DETERMINATION OF DEVELOPMENT APPLICATION

Clouston Associates has amended the proposed drawing package to incorporate the following changes, highlighted in the Penrith City Council, City Works Department Comments for the Development Application (DA No.DA14/0209).

VILLAGE OVAL JORDAN SPRINGS

LANDSCAPE DEVELOPMENT APPLICATION

Section B-B

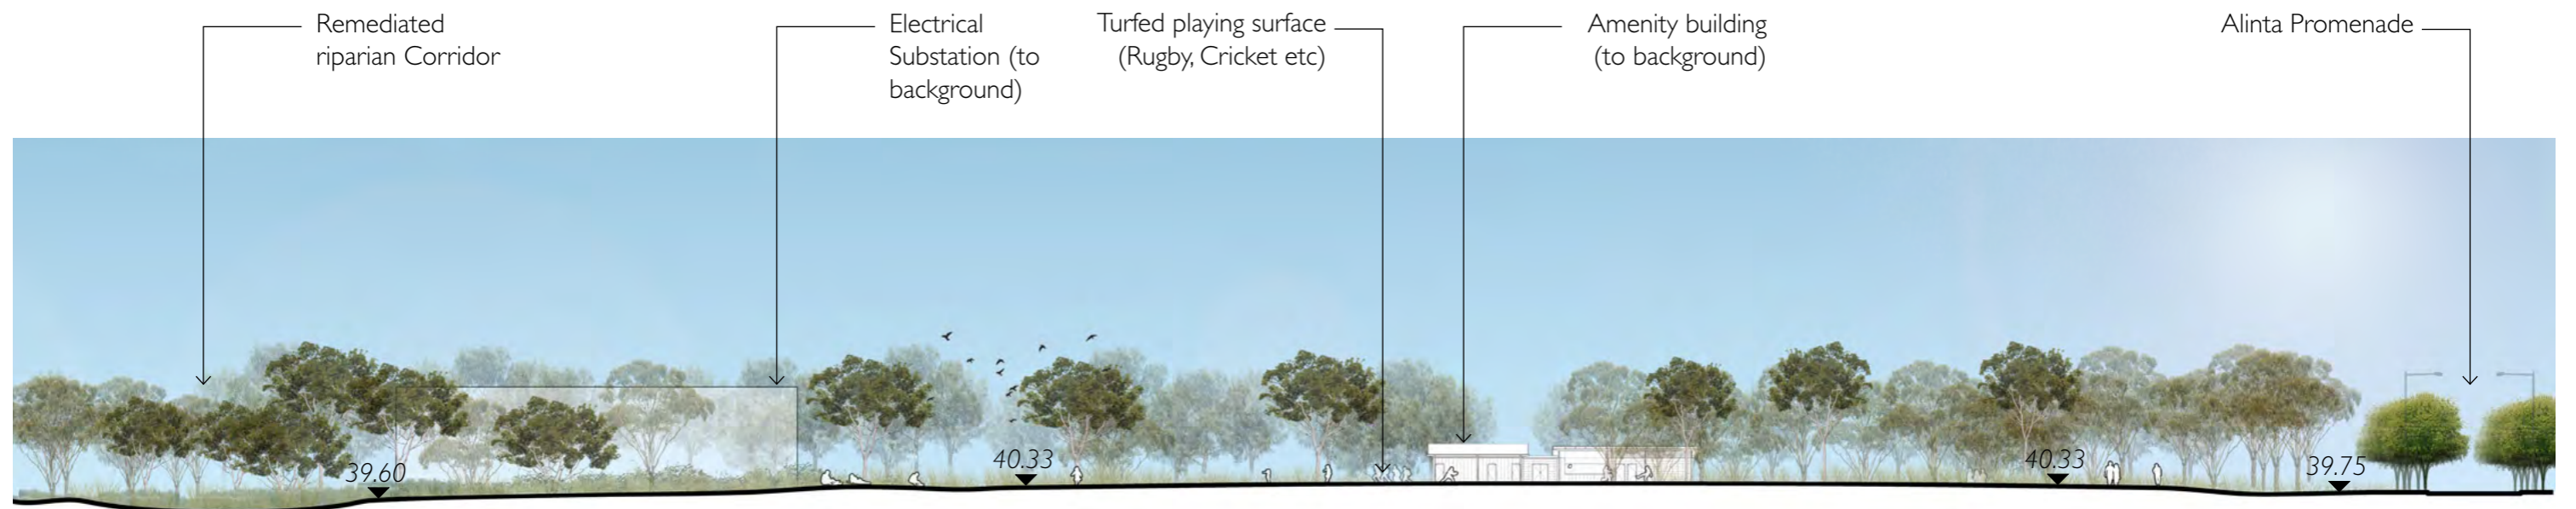
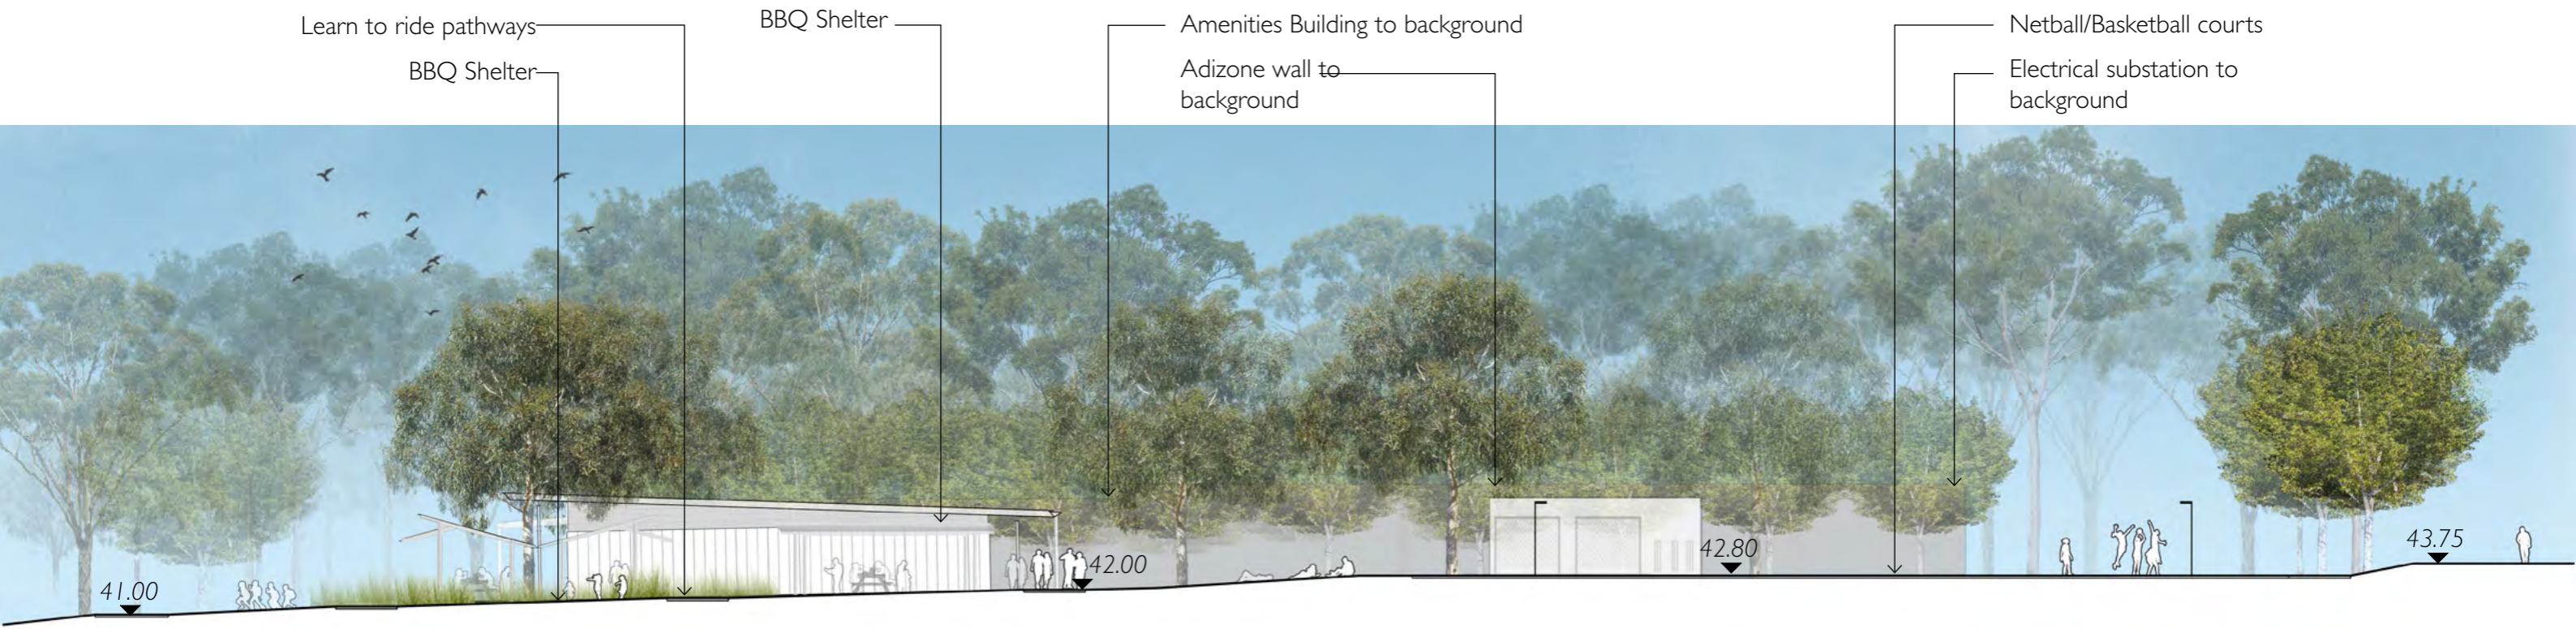
- Further contour detail should be provided around the grass mound. **Provided**
 - Section BB, on drawing JOR-0003 DA5 shows an RL 40.33 twice and there is a clear height difference between the two. This detail should be clarified. **Amended**

Drawing
 GROUND FLOOR PLAN

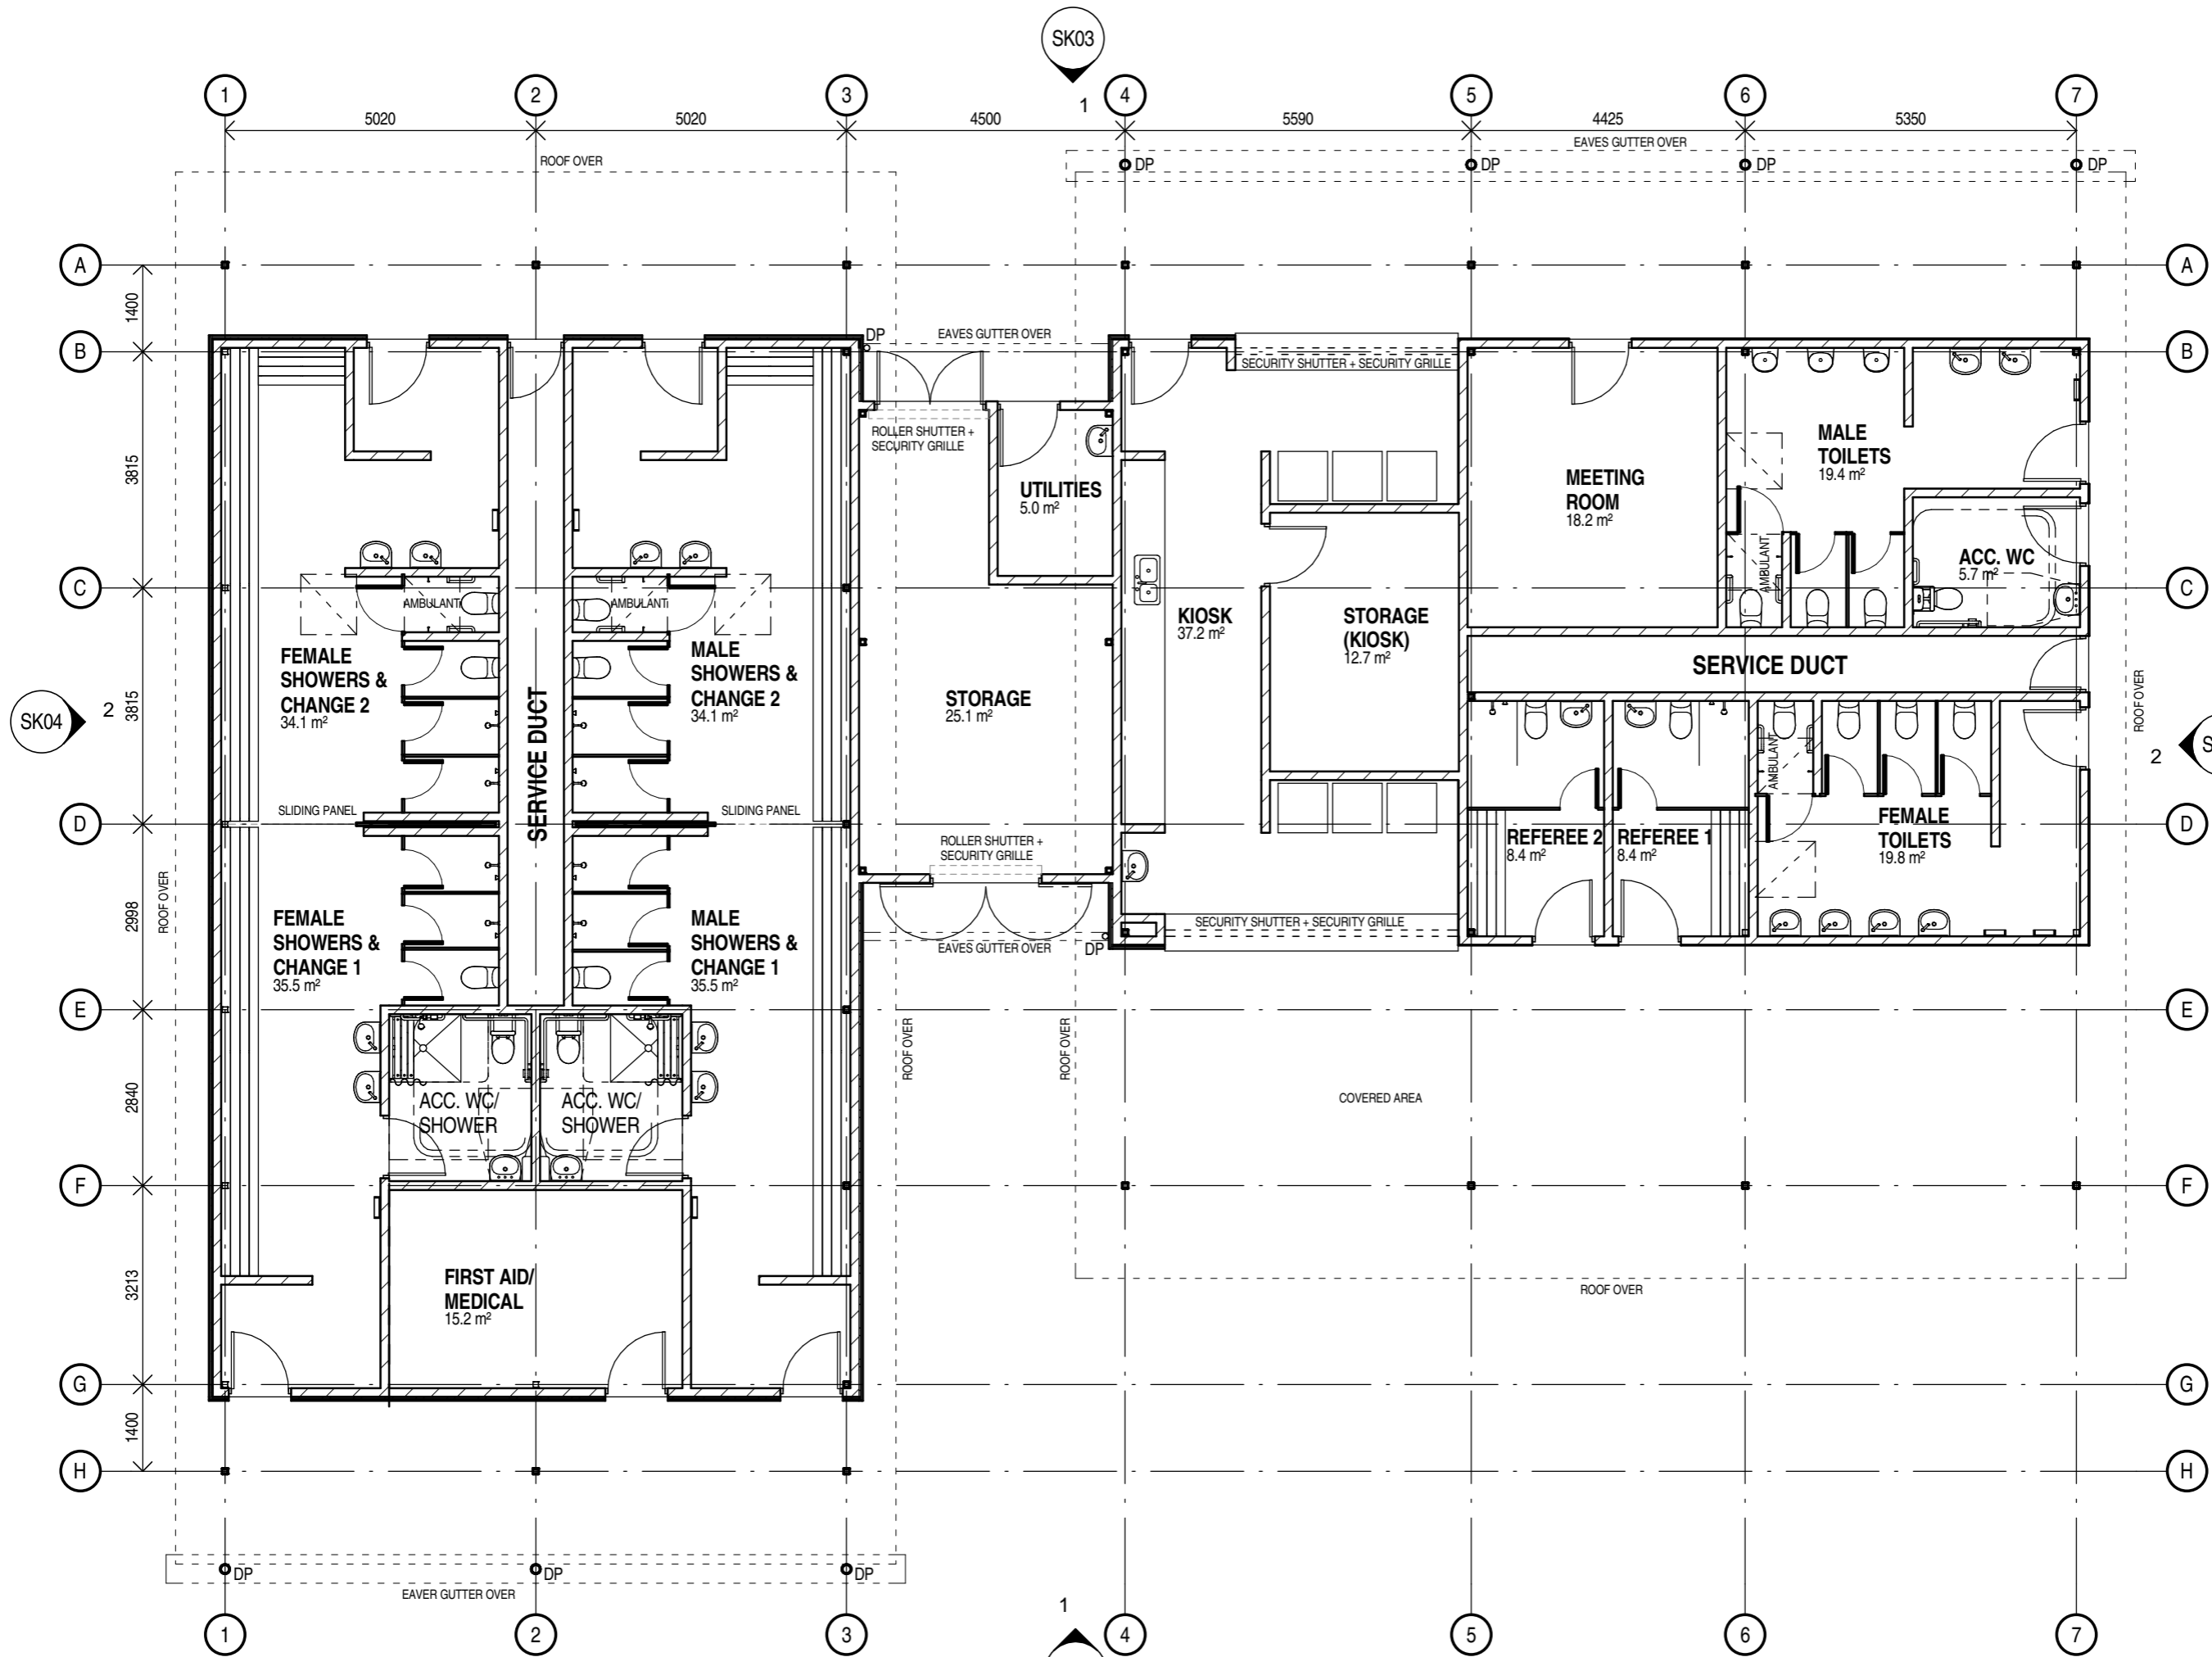
- a) High level middle roof section should fall outwards to eliminate the necessity of a box gutter as follows: **Box gutter deleted**
 - This box gutter will be costly to maintain and would require monthly cleaning of

- Generally every building that Council owns that has box gutters leak and is a
 - constant maintenance issue.
- b) The structural steel columns supporting the high level centre roofing should be removed/ relocated into the adjacent brick wall. This will achieve a number of benefits, an easy to clean corridor, no impediments for visually impaired and other people, nothing for people to climb and reduced clutter. **Central roof (breezeway) deleted**

- c) The drawings indicate there are structural steel columns on most gridline intersections, these will need to be relocated into the adjacent walls, so that the room doesn't have steel columns sticking out making it not as usable. There are also some columns that are in the middle of work areas, these need to be relocated in the walls (utilities and kiosk area). **Structural steel columns revised to be incorporated into architectural walls.**

- d) The amenities building structure itself raises CPTED concerns due to the potential of entrapment resulting from the breezeway. A redesign should be considered to respond to access control, provision of passive surveillance and prevent entrapment concerns. In this regard it would be preferred that the 2 structures be combined as one single building with no provision for breezeways or areas of entrapment. **Breezeway terminated. Architectural footprint revised to comments**

TURNING PATH
SCALE 1:200

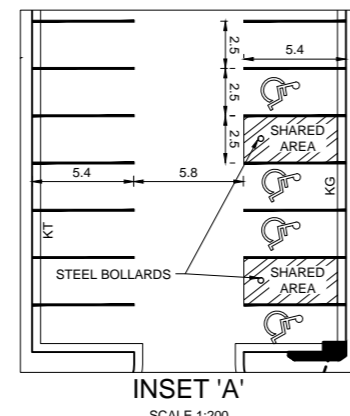
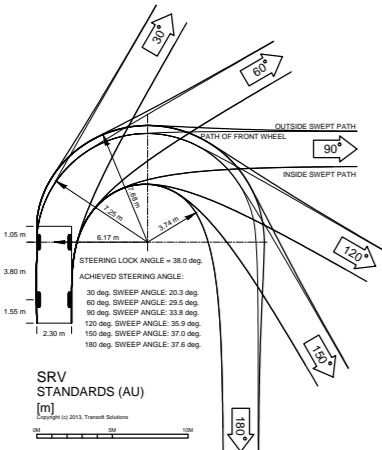
- Please provide turn paths for the proposed car parking facility. **Provided**
 - All pram ramps shall demonstrate a 1:8 grade this shall be detailed on the engineering plans. **Details regarding gradients are to be addressed at CC stage**
